MCPB
10.9.03
Item #9

MEMORANDUM

REVIEW TYPE: Site Plan Review
CASE #: 8-03040
PROJECT NAME: Kingsview Village
APPLYING FOR: Approval of 4 One-family Detached Homes
REVIEW BASIS: Site Plan Review is required for R-200 TDR Optional Method [§59-C-1.393] of the Montgomery County Zoning Ordinance

1. Building Line and House Location

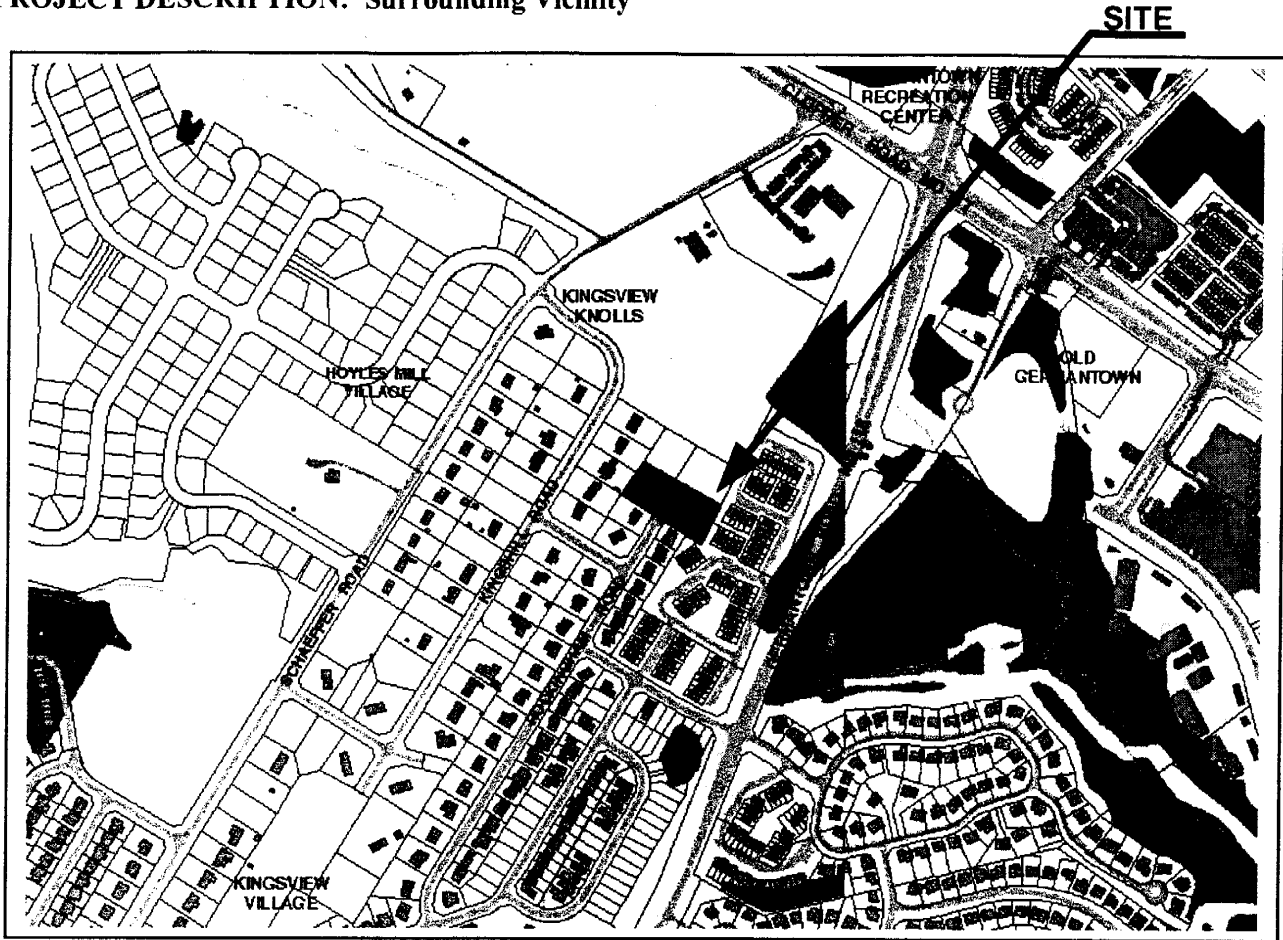
The application initially proposed a greater setback from the public street.

- Applicant Position: Applicant proposed a setback of 60 feet from the public street, which has been revised per staff recommendations.
- Community Position: No comment has been received from the Community at the time of staff report publication.
- Staff Recommendation: The building line established along the public street for the majority of houses and their primary massing measures approximately 40 feet. Staff recommends that the proposed plan utilize a similar setback to achieve greater compatibility in the character of the street.

PROJECT DESCRIPTION: Proposal

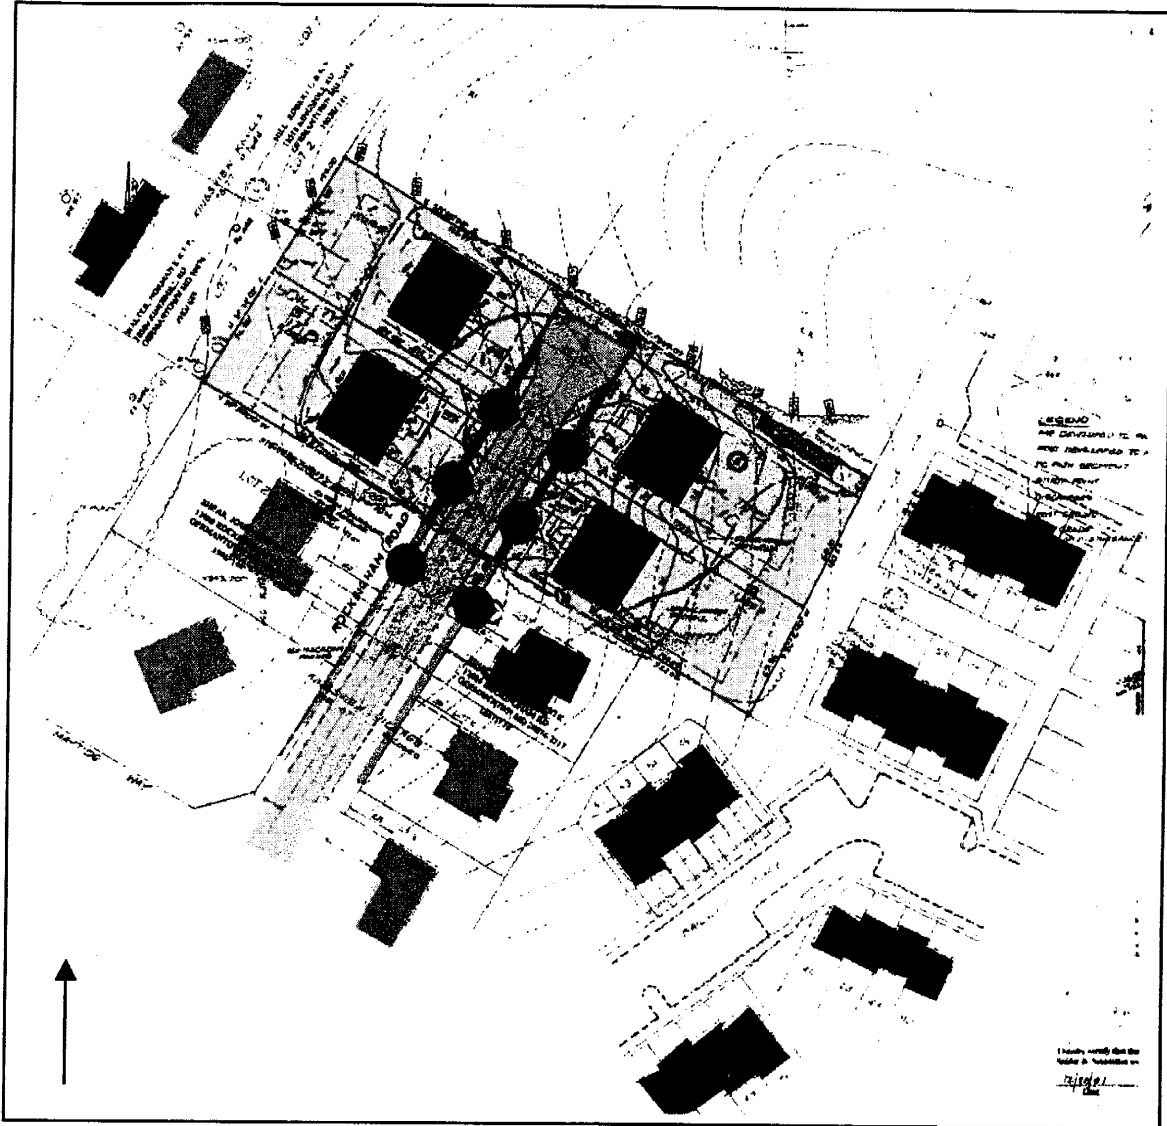
The initial proposal provided four street trees within the public right-of-way.

- Applicant Position: Applicant has revised the plan to provide six street trees within the right-of-way.
- Citizen Position: No comment has been received from the Community at the time of staff report publication.
- Staff Recommendation: The plan proposes the extension of Rockingham Road, and hence, an extension of the existing community that faces the Rockingham Road street frontage. The existing Rockingham Road was terminated by a “hammer-head” turn-about, which precluded the provision of street trees at the north end of the right-of-way. Staff recommends that the applicant provide two trees for the finished connection of the street frontage.
